33520B-03

Modification Recommended Service Note

33500 Series Waveform Generator

The Problem – The dot key  on front panel intermittently not active.

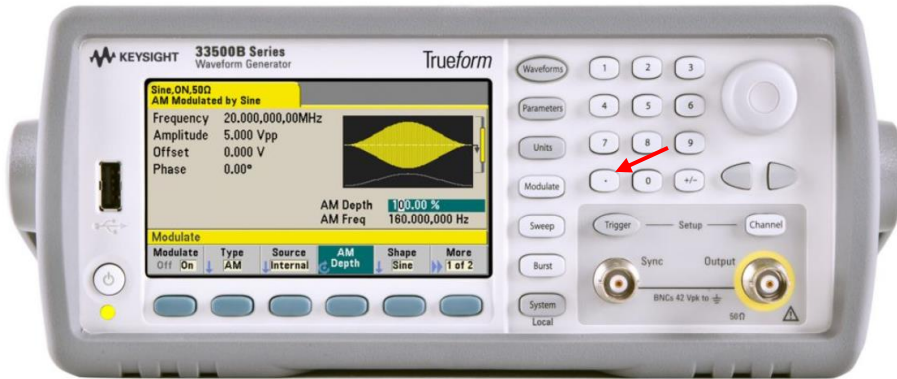
User may experience the dot key on the front panel intermittently inactive when pressed.

For units with inactive dot key, please return units back to Service Center for repair.

1. Replace the front panel board (part number: 33500-66308).
2. Turn on the instrument and check if the dot key is active when pressed.
